HISTORIC AND DESIGN REVIEW COMMISSION

October 19, 2022

HDRC CASE NO: 2022-506
ADDRESS: 825 E HARLAN AVE
LEGAL DESCRIPTION: NCB 7729 BLK 9 LOT E 171.7 FT OF 11 THRU 14, EXC SE 6.50FT X 10.15FT
ZONING: MF-33, H
CITY COUNCIL DIST.: 3
DISTRICT: Mission Historic District
APPLICANT: Kevin Sekula/SEKULA KEVIN
OWNER: Kevin Sekula/SEKULA KEVIN
TYPE OF WORK: Installation of doors and windows, driveway modifications
APPLICATION RECEIVED: September 19, 2022
60-DAY REVIEW: Not applicable due to City Council Emergency Orders
CASE MANAGER: Jessica Anderson
REQUEST:

4.)

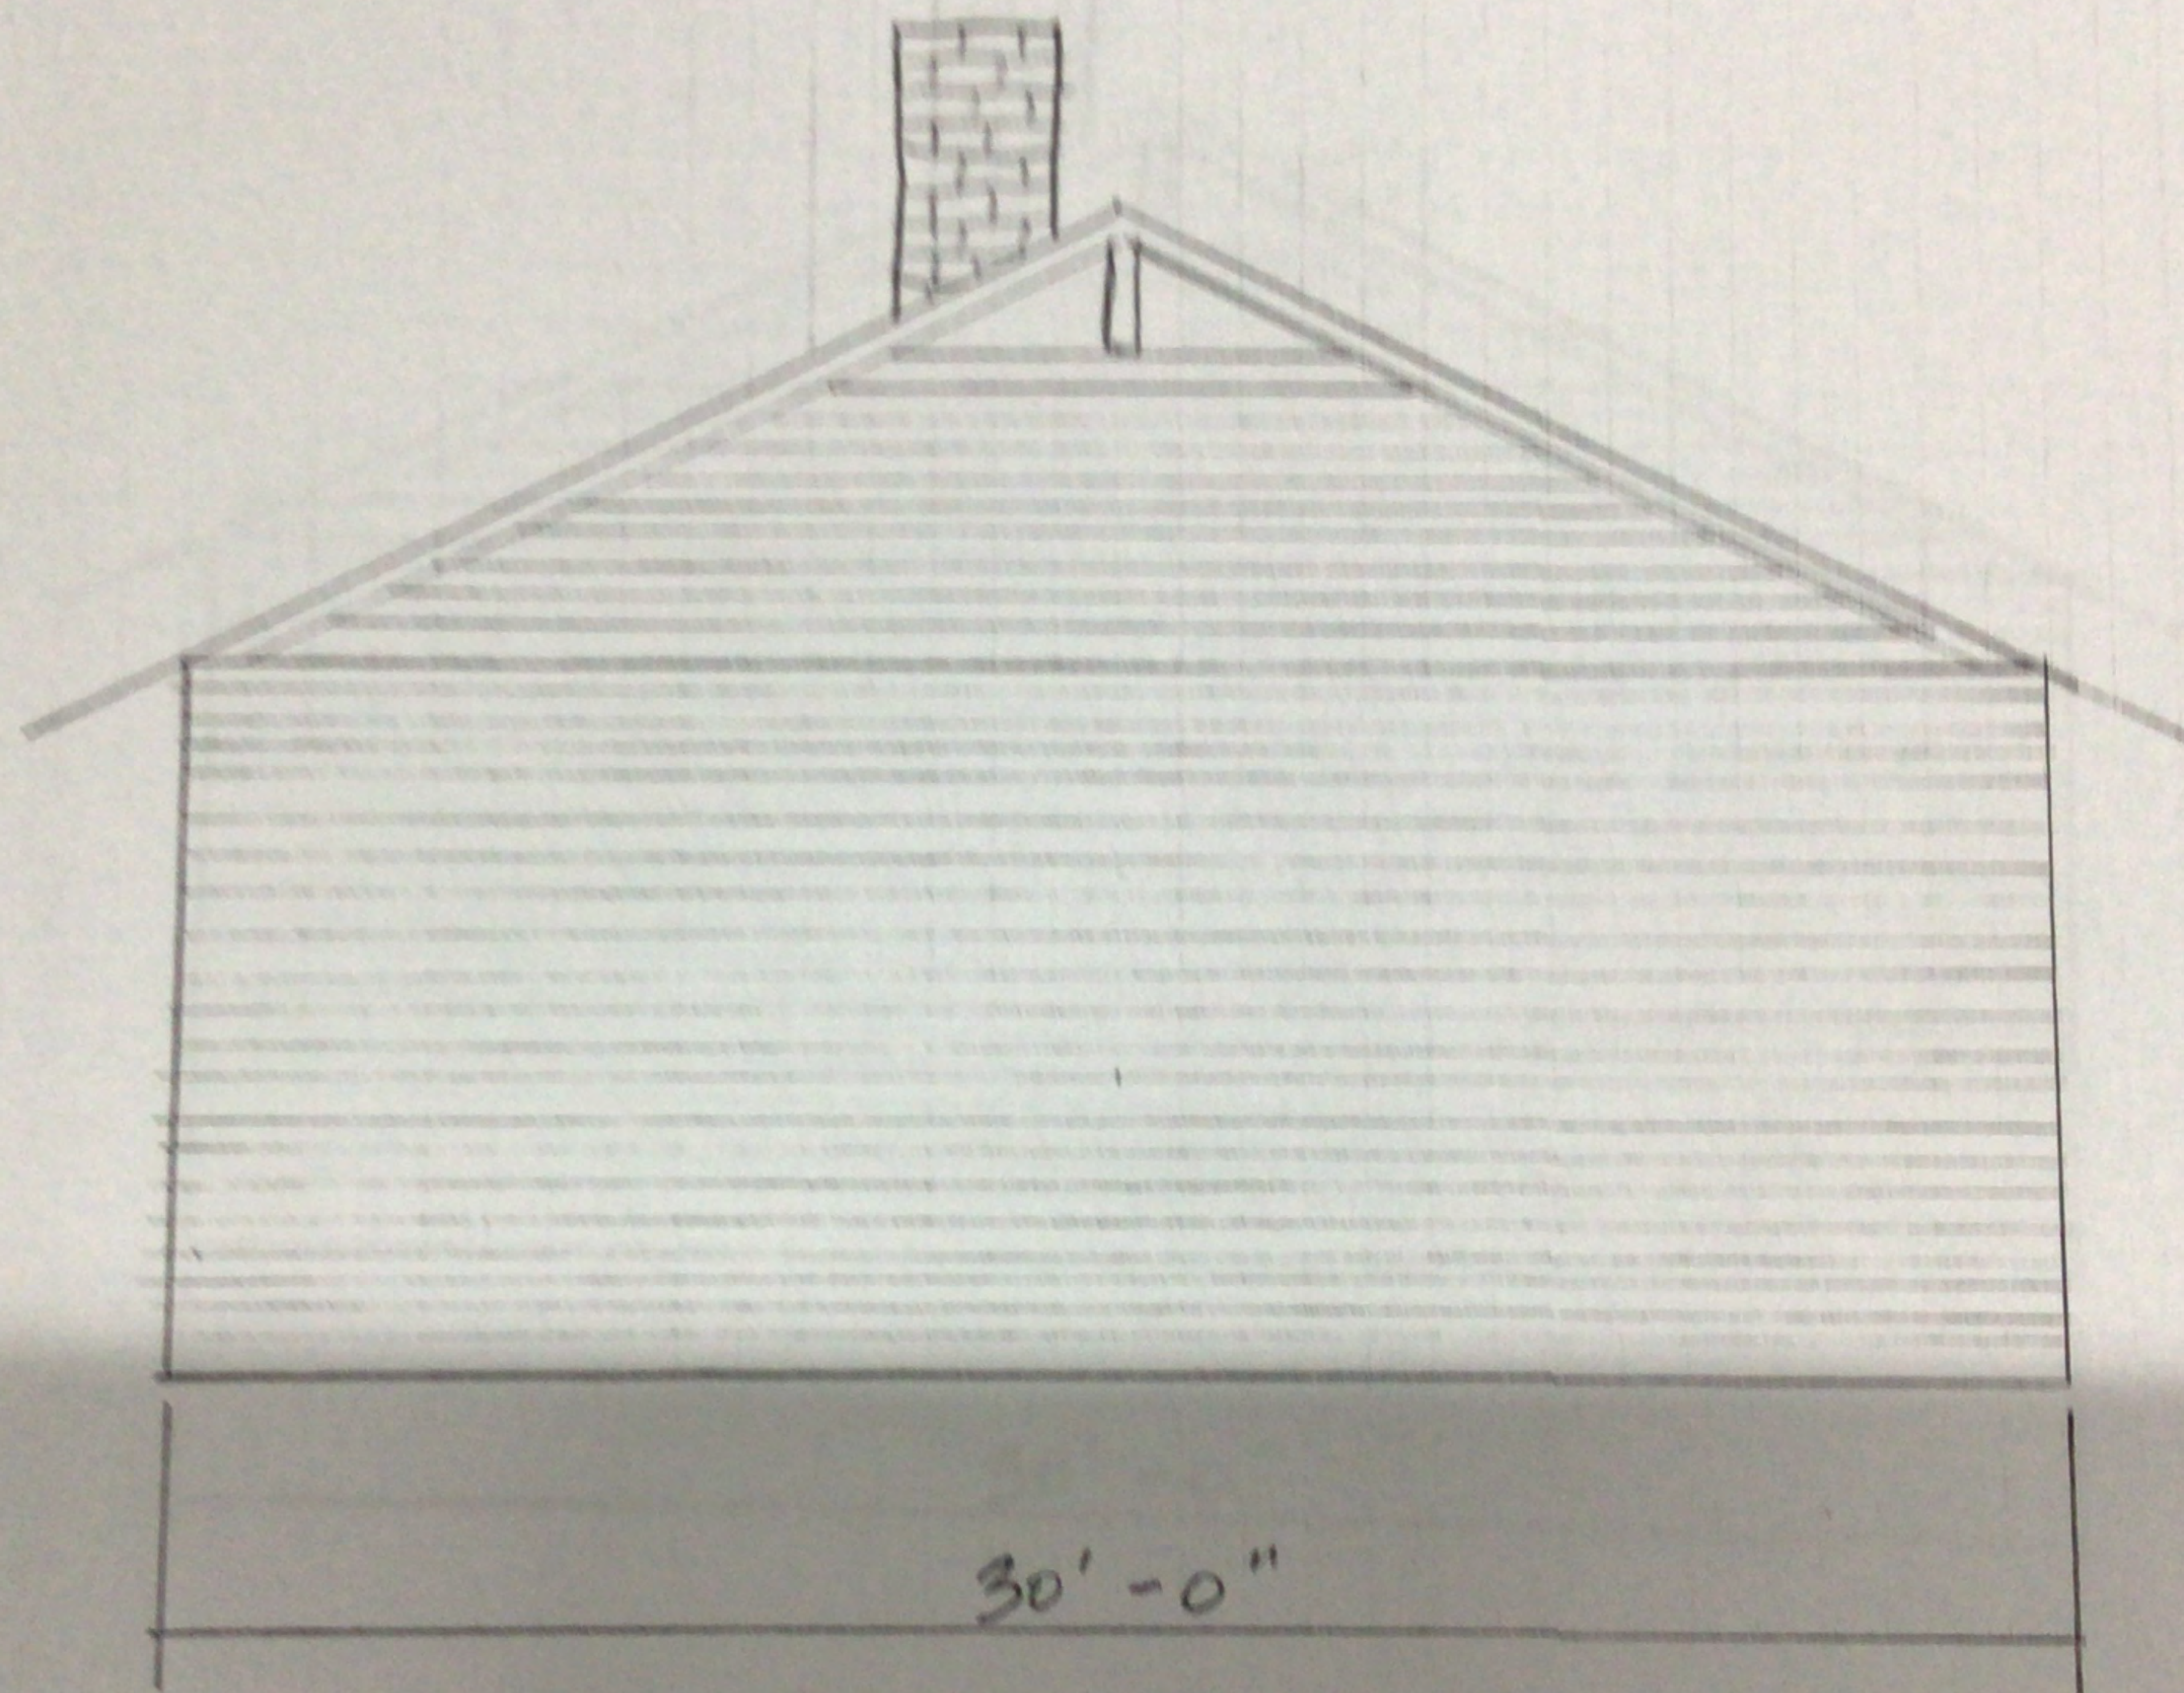
W1 - MOVE & FROM 10'-7" TO 7'-6"

D1 - DELETE

W2 - CHANGE TO EXT. DOOR 3' 6"

W3 - CHANGE & FROM 7'-1" TO 5'-6"

W5, D2 & W6 REMOVE & MATCH W4

D3 - CHANGE TO SINGLE 4' 6"

W7 - NO CHANGE

W8 - CHANGE FROM DBL TO (2) SINGLE 1" TALL X 3" WIDE

W7A - ADD (1) SINGLE 1" TALL X 3" WIDE

W9 - DELETE

Staff does not recommend approval of item 3, changing the fenestration pattern across all elevations, based on finding d.
